B.3.c Groundwater Flow Direction
 VPI Property
 3123 S. 9th Street
 Sheboygan, Wisconsin

From: Trent Ott <tott@fecinc.us>
Sent: Wednesday, August 12, 2020 2:57 PM
To: LeRoy, Bruce J - DNR (BJ)
Subject: Re: BRRTS Activity 02-60-001045
Attachments: VPI GW Contour Portrait (1).pdf

Figure
 B.3.c

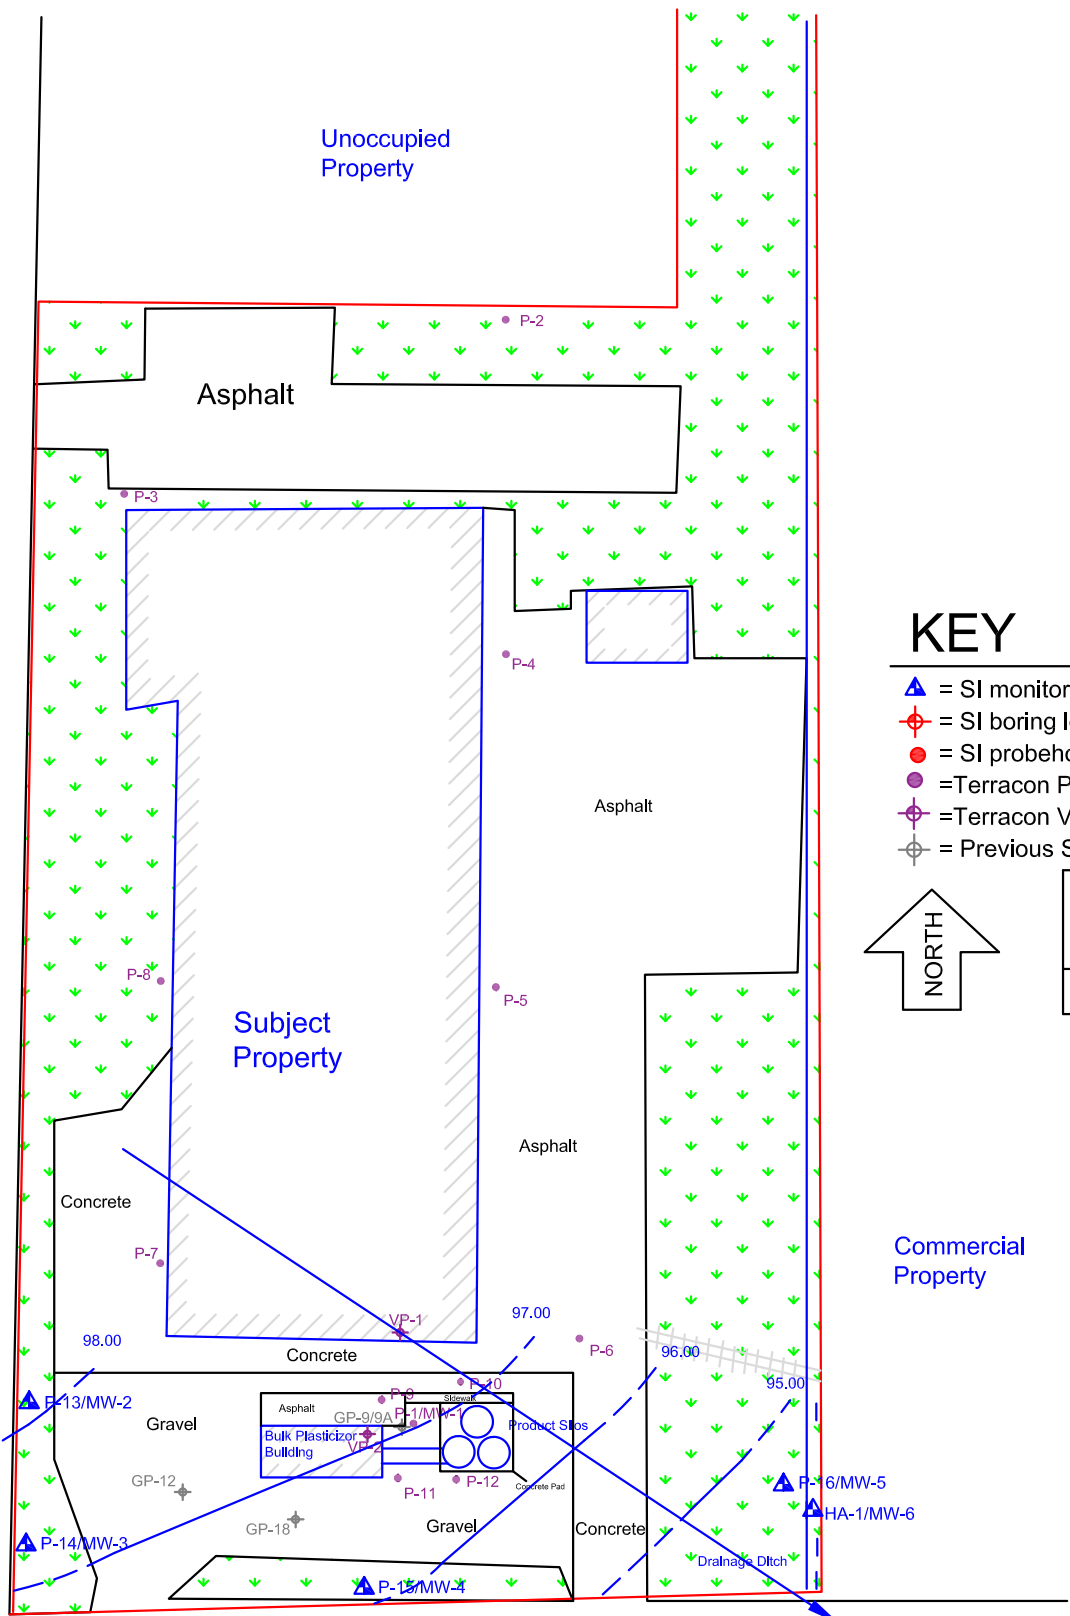
- The ES exceedances at MW-5 and MW-6 are a concern. They think the nature and extent isn't defined there, possibly going off-site.
- The flow map needs a little work; as it's drawn, flow is more to the south than the arrow indicates, so I'd look to see if you've got the equipotentials correct, and then make sure your flow arrow is perpendicular to the equipotentials. As it's drawn, we'd want to see a well between MW-4 and MW-6, to see if the plume migrates that direction. Maybe the equipotentials aren't quite right, so that well doesn't make sense, I don't know. Your job to evaluate that one.

- I did look at the flow map and agree that the flow arrow is off and would be more to the southeast. An updated figure is attached. Before installing an additional well I would suggest to confirm the flow direction.
